Service Bulletin:

AirForce Brackets in Lift Conversion Kit 726525 for JD 17XX/72XX/73XX planters model year 2011+

February 24th, 2011

Installation instructions update including modification of existing bracket 726551 and replacement of 726135 AirSpring Connector Stud

Modification of existing 726551 AirSpring Head Mount brackets

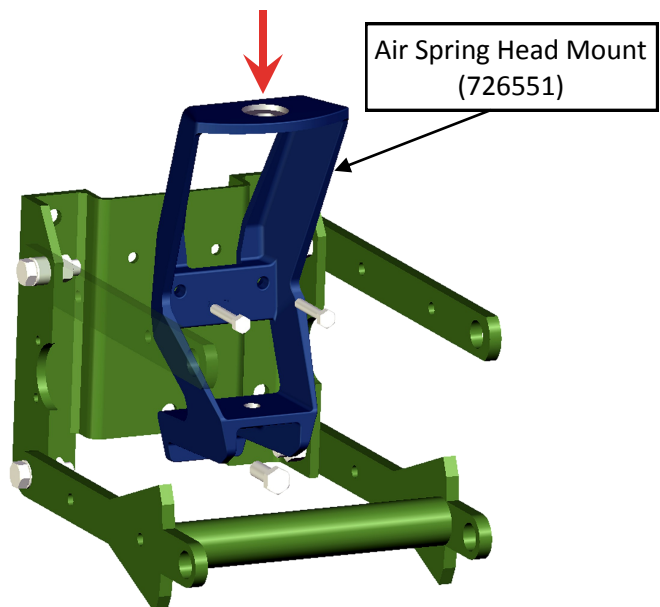
On model year 2011+ JD planters 17XX/7200/7300 the OEM JD airspring has changed from previous model years. The pneumatic fittings into the top stud of the airspring have changed from 1/8" NPT X 1/4" PTC to 1/4" NPT" X 3/8" PTC. To accommodate this change, the top stud of the airspring has been enlarged. These larger airspring studs do not fit into Precision Planting AirSpring Head Mount brackets (726551) that have not been retrofitted. New production and existing in-house inventory, as of January 2011, of the 726551 bracket are being retrofitted to accommodate this new airspring. For 726551 brackets, being installed on the affected planters, that have not been retrofitted, this can be easily accomplished in the field using a 7/8" drill bit to ream the hole wide enough to accommodate the larger airspring stud. This may be completed as installed on the planter planter or prior to installation using a standard drill or drill press.

Replacement of AirSpring Connector Stud - 726135 (SAE) with 726706 (Metric)

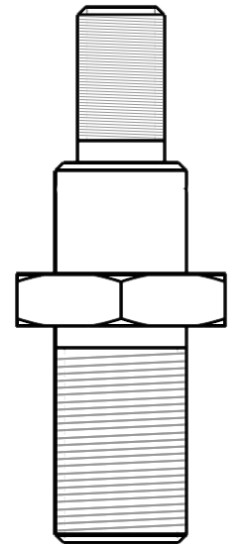
A second impact to the OEM airspring changes is the move to metric threads into the base of the airspring. To accommodate these new thread styles on affected planters replace the 726135 connector stud with the supplied 726706 for Metric threads. New production and in-house inventory, as of January 2011, of the 726595 hardware kit (supplied with each 726525 Lift Conversion Kit) will include both SAE and Metric Airspring Connector Studs. For planters made:

Prior to MY2011: Use the yellow plated connector stud, part number 726135. This connector has SAE 1/2-13 UNC threads to match the airsprings used on those model year planters.

MY2011 and after: Use the clear plated connector stud, part number 726706. This connector has Metric M12 X 1.75 ISO threads to match the airsprings used on those model year planters.
